Title of Change:	SOD523 carrier tape pocket dimension and design change
Effective date:	08 Sep 2020
Contact information:	Contact your local ON Semiconductor Sales Office or Jim.Peng@onsemi.com
Type of notification:	This Product Bulletin is for notification purposes only. ON Semiconductor will proceed with implementation of this change upon publication of this Product Bulletin.
Change Category:	Assembly Change
Change Sub-Category(s):	Carrier tape pocket change

Description and Purpose:

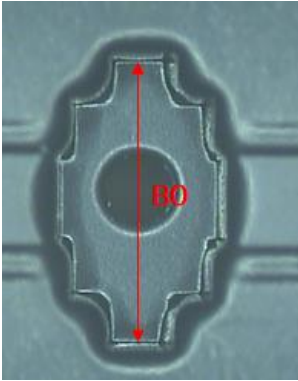
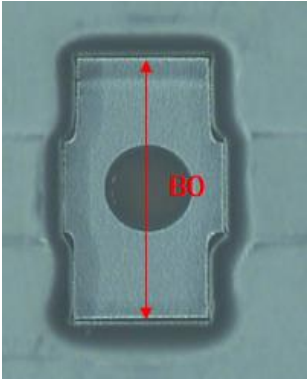
This product bulletin announces the improved SOD523 carrier tape pocket. The improved SOD523 carrier tape pocket will eliminate potential risk of unit jammed in carrier tape pocket. All new product releases currently incorporate this type of carrier tape and products listed in this product bulletin are being converted after the effective date.

Before Change	After Change
Carrier Tape Pocket Shape	With pocket lead guide area 	Without pocket lead guide area 
Carrier Tape Pocket Length(B0)	1.95±0.05 mm	1.80±0.05 mm

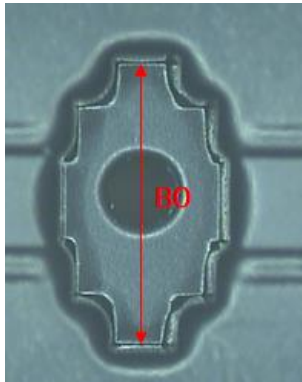
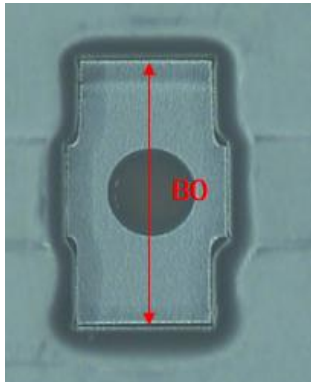
本製品速報は SOD523 キャリアテープポケットの改良についてお知らせするものです。改良後の SOD523 キャリアテープポケットは、製品がキャリアテープポケットに詰まる潜在的なリスクを排除します。現在すべての新製品はこのタイプのキャリアテープを取り入れてリリースされており、本製品速報に記載された製品は本速報の発効日以降に変更されます。

変更前の表記	変更後の表記
キャリアテープポケットの形状	ポケットリードガイド領域あり 	ポケットリードガイド領域なし 
キャリアテープポケットの長さ(B0)	1.95±0.05 mm	1.80±0.05 mm
